**SUBJECT: CALVERT CLIFFS NUCLEAR POWER PLANT, UNIT NOS. 1 AND 2 -  
ISSUANCE OF AMENDMENT RE: REVISION TO PRESSURIZER SAFETY  
VALVE TECHNICAL SPECIFICATIONS (CAC NOS. MF3541 AND MF3542)**

SAFETY EVALUATION BY THE OFFICE OF NUCLEAR REACTOR REGULATION

RELATED TO REVISION OF PRESSURIZER SAFETY VALVE

CALVERT CLIFFS NUCLEAR POWER PLANT, UNIT NOS. 1 AND 2

**Figure 1** TRACE Pressure Response for 0.02 sq. ft. FWL Break - level biased low

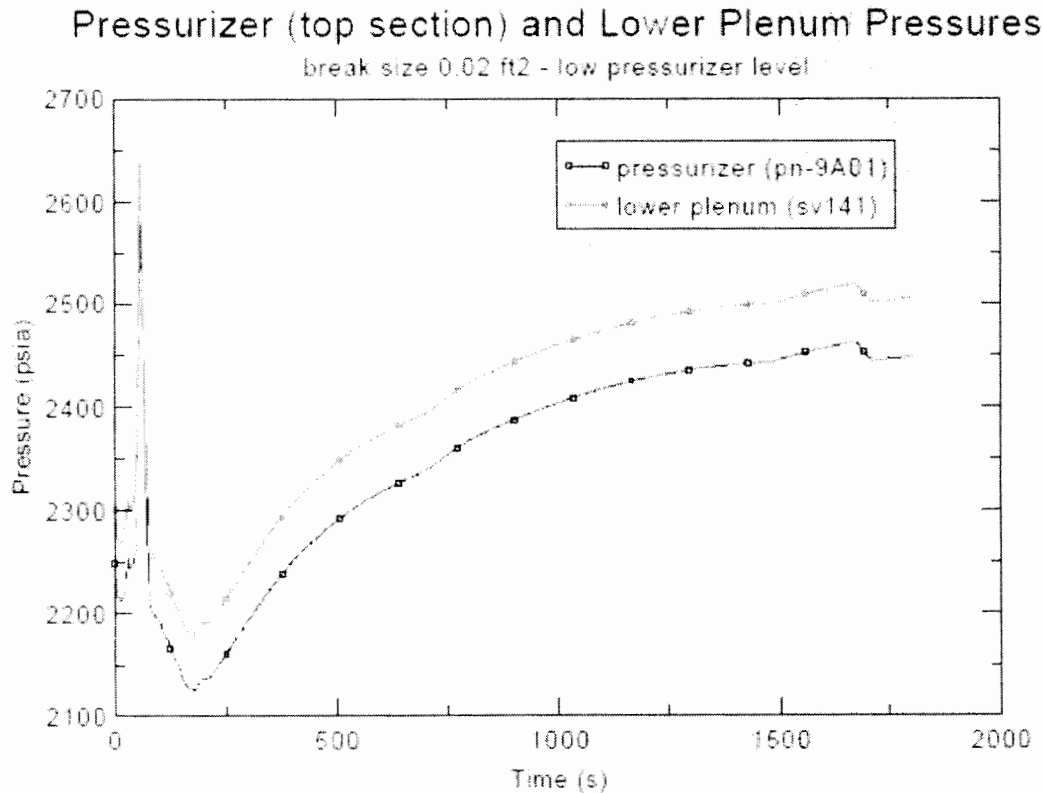
A plot of peak pressure at the bottom of the RPV and pressure at the safety valve are shown for the limiting case in Figure 1. There are two local peaks in the pressure for each case, one for small breaks and one for larger breaks. Based on the results of the confirmatory calculations the NRC staff made the following observations:

1. The peak pressures for the confirmatory analysis are significantly lower than the peak pressures reported by AREVA. This may be due to conservatism that were not readily apparent from the AREVA documentation, and were therefore not included in the TRACE model. Both the TRACE code and the base CCNPP input model are best estimate.
2. The TRACE calculations are in agreement with the S-RELAP5 calculations in terms of the break sizes that yield local peak pressures, namely 0.02 sq. ft. and 0.34 sq. ft.
3. The double peak nature of the pressure response and the small difference between the peak pressures explains how a significant difference in limiting break size can occur.
4. The TRACE code analyses performed by the staff confirm that the peak pressurization results presented in the AREVA feedwater line break calculation are conservative and provide adequate support for the subject LAR.

As explained above, the TRACE confirmatory analyses demonstrate that the licensee's analyses to support the proposed changes in the as-found PSV lift setpoints are conservative. Moreover, calculations with the TRACE code confirmed that the peak system pressure for the limiting feedwater line break event will not exceed 110% of the design pressure, in accordance with the ASME Code, Section III, Article NB-7000.
